# UNITED STATES PATENT AND TRADEMARK OFFICE

APPLICATION NO.	FILING DATE	FIRST NAMED INVENTOR	ATTORNEY DOCKET NO.	CONFIRMATION NO.
09/683,354	12/18/2001	Joseph Neyman	neyman	3946

**Office Action Summary**

## **DETAILED ACTION**

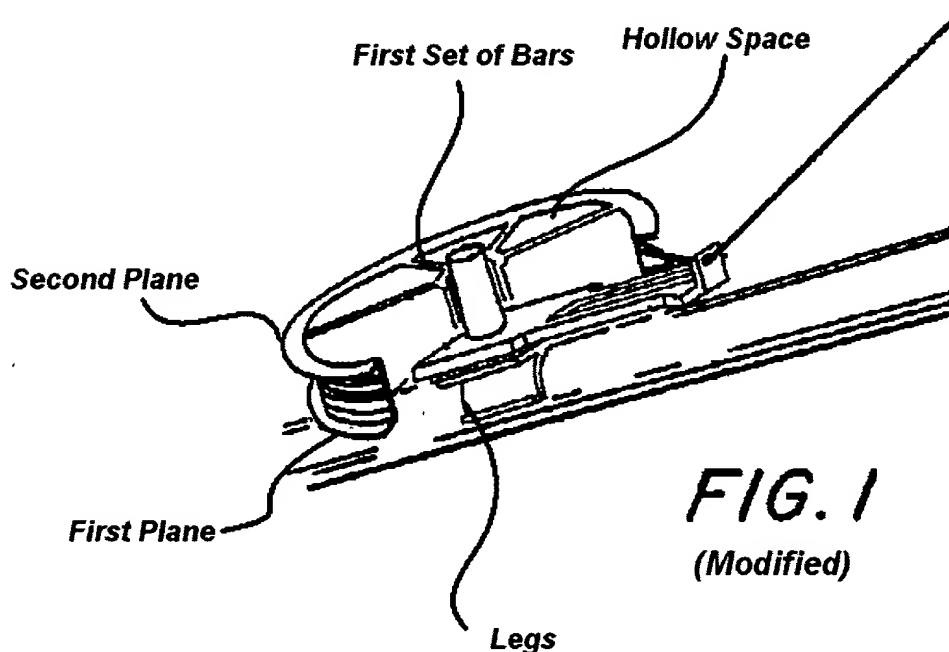
Sherbondy discloses a fishing line apparatus comprising a first elongate plane, a first set of bars, a second set of bars communicating with the first plane (not shown in figure 1, as it a cutaway of the cross-section), a series of legs communicating with the first plane for attaching to the rod of the fishing pole, a generally elongate second plane communicating with the first and second set of bars wherein the first plane and second plane are generally elongate (as they have a length) in parallel to the rod of the fishing pole (see figure below).

Regarding claim 12, Sherbondy disclose a hollow space between the first and second set of bars communicating with the first and second planes.

Regarding claim 13, Sherbondy discloses the first and second series of bars creating curvatures from the middle to the exterior of the plans
